ADDENDUM NUMBER 3

Project Number 89020267 TAP-3324 (411)

Project Title (Reissue) Rte. 152 Trail – Seg. 10 Pedestrian Bridge over

ISSUE DATE: 06/24/2026

**EAST WALL
 PLAN & PROFILE**

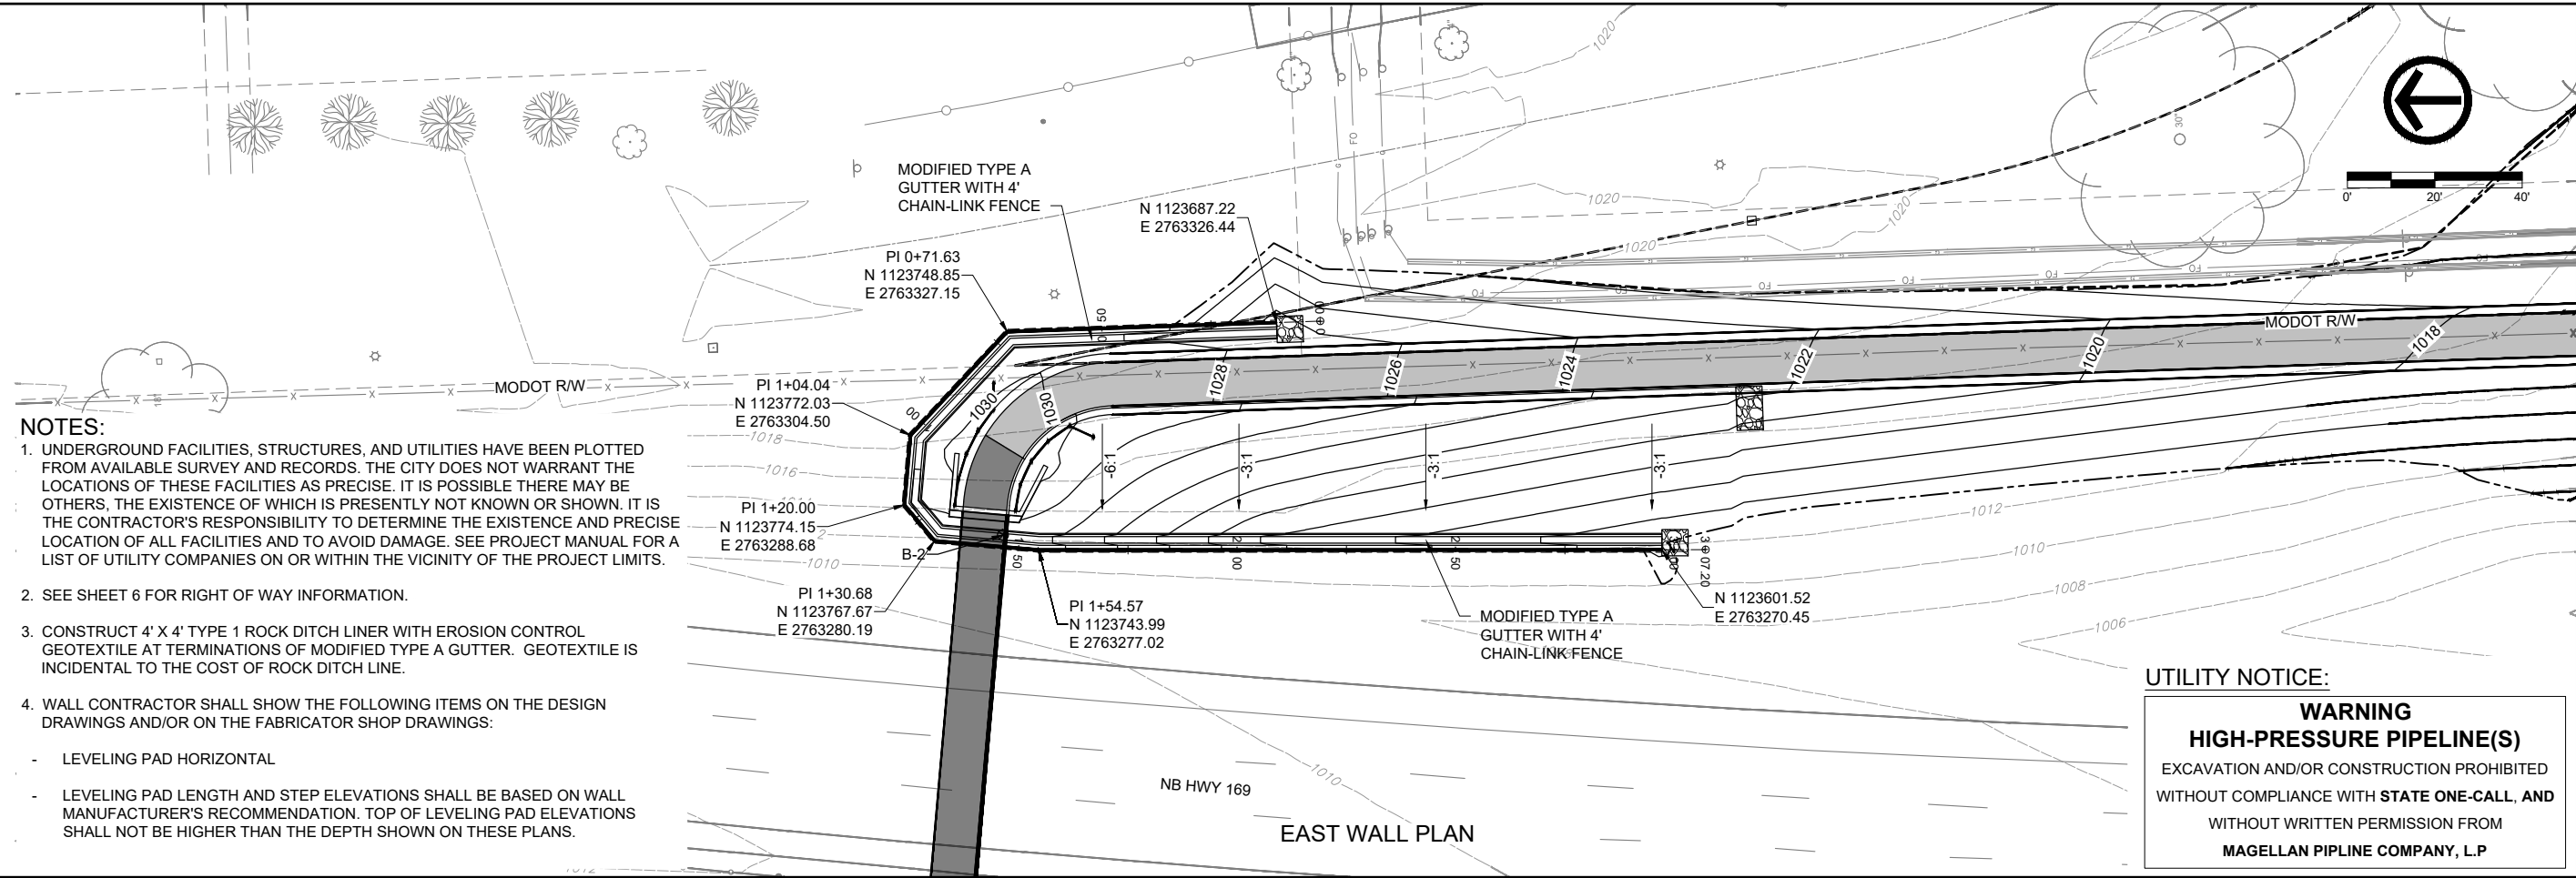
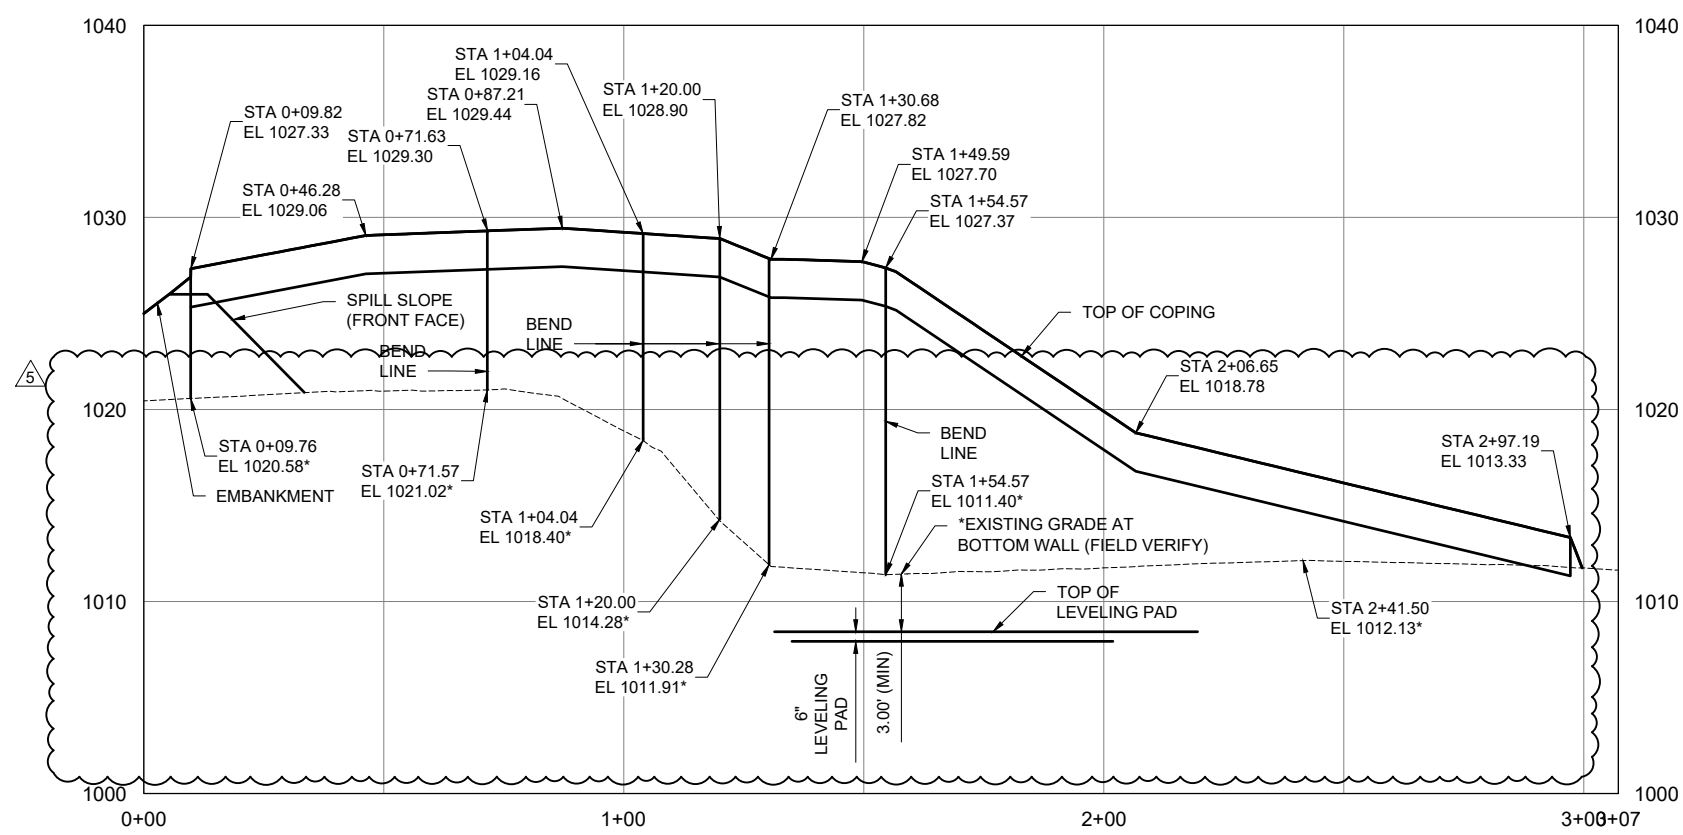
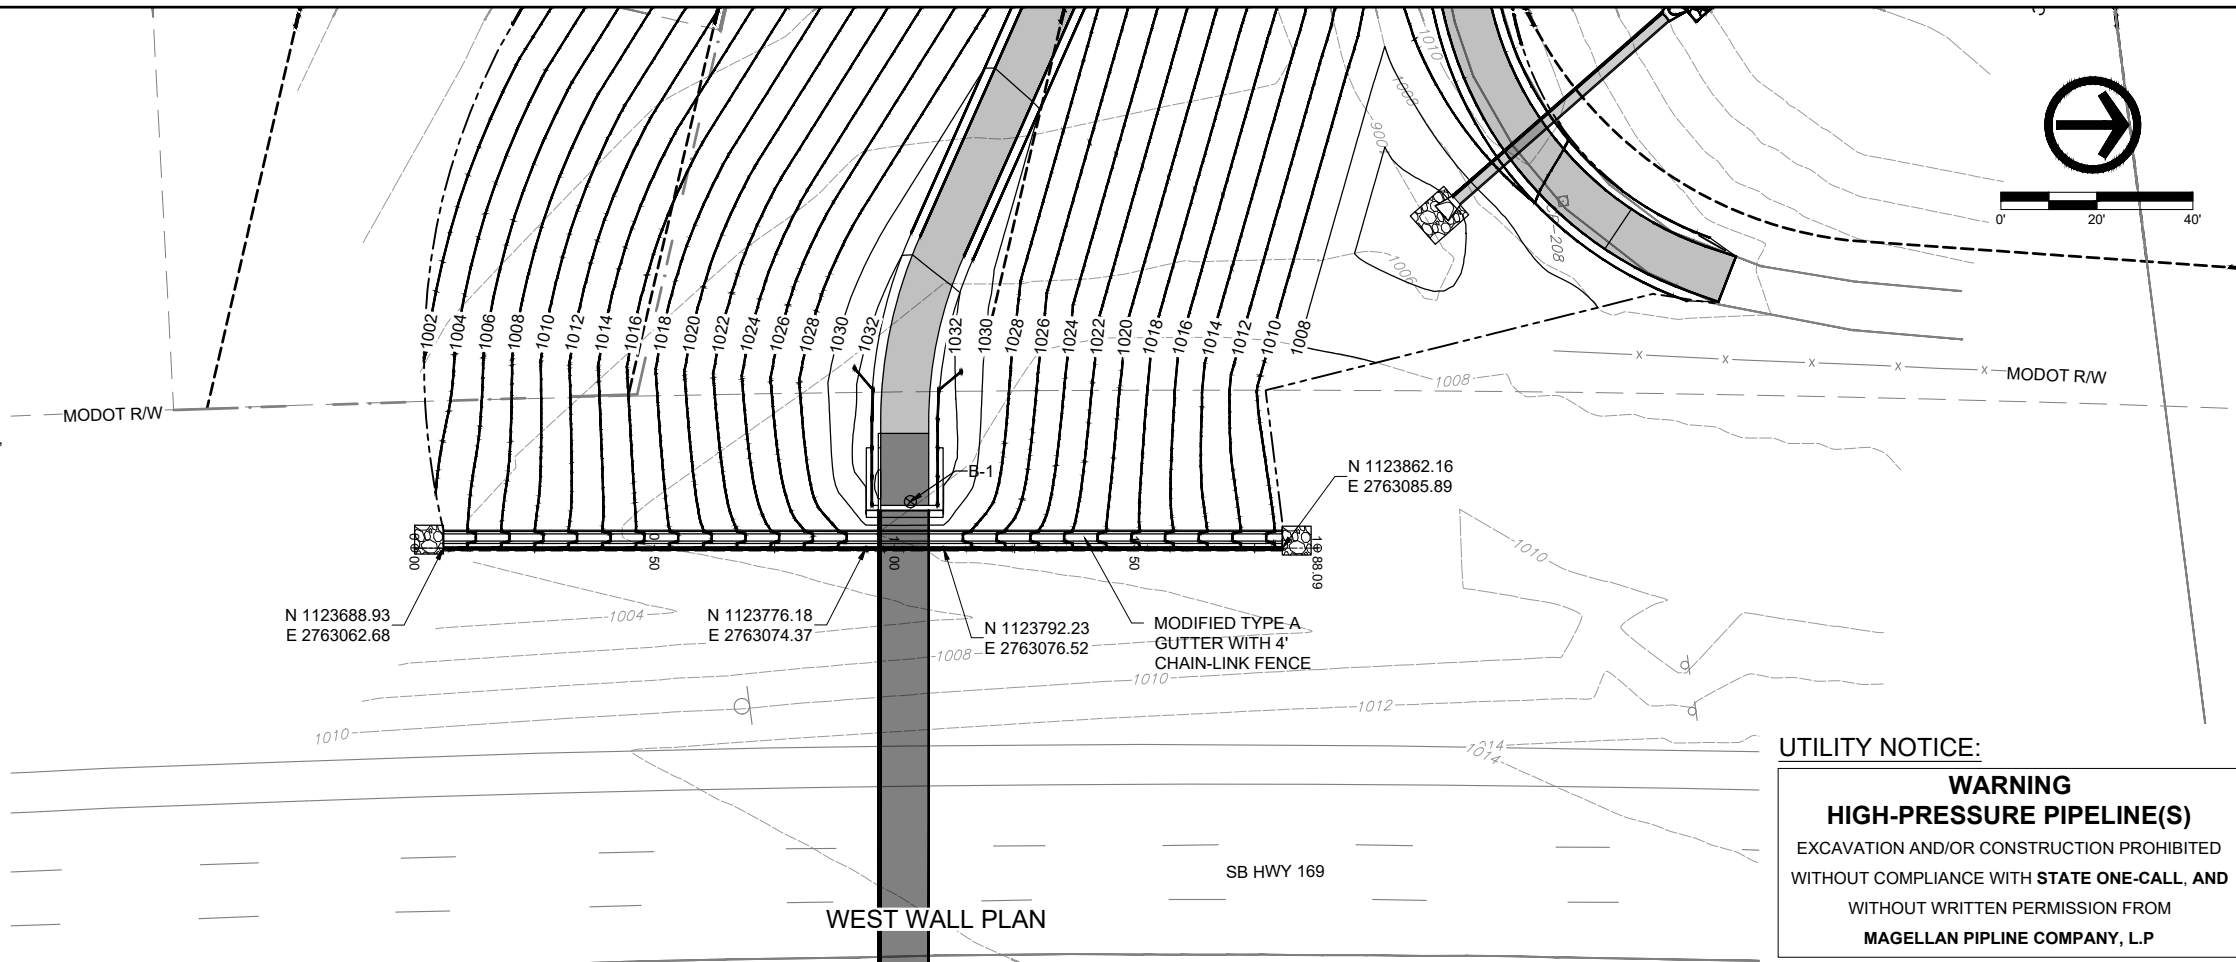
20. Can stationing and elevations for the MSE wall leveling pad and finished grade line be provided? Please see revised plan sheets W1 and W2 depicting stationing and bottom elevations for the proposed finished grade at the wall face or top of leveling pad.

Leveling pad elevations are set by the manufacturer based on an economic arrangement of the wall pieces. Contractors are to place the depth based on the parameters set on the plans. Also, the "proposed" groundline is the "existing" groundline and the contractor should verify it since it has been years since it was surveyed. (See Page 5 and Page 6 for W2 East Wall and W1 West Wall)

DATE	DESCRIPTION
06-08-2026	ADDENDUM 5 - EX. GRADE CALL-OFFS ADDED
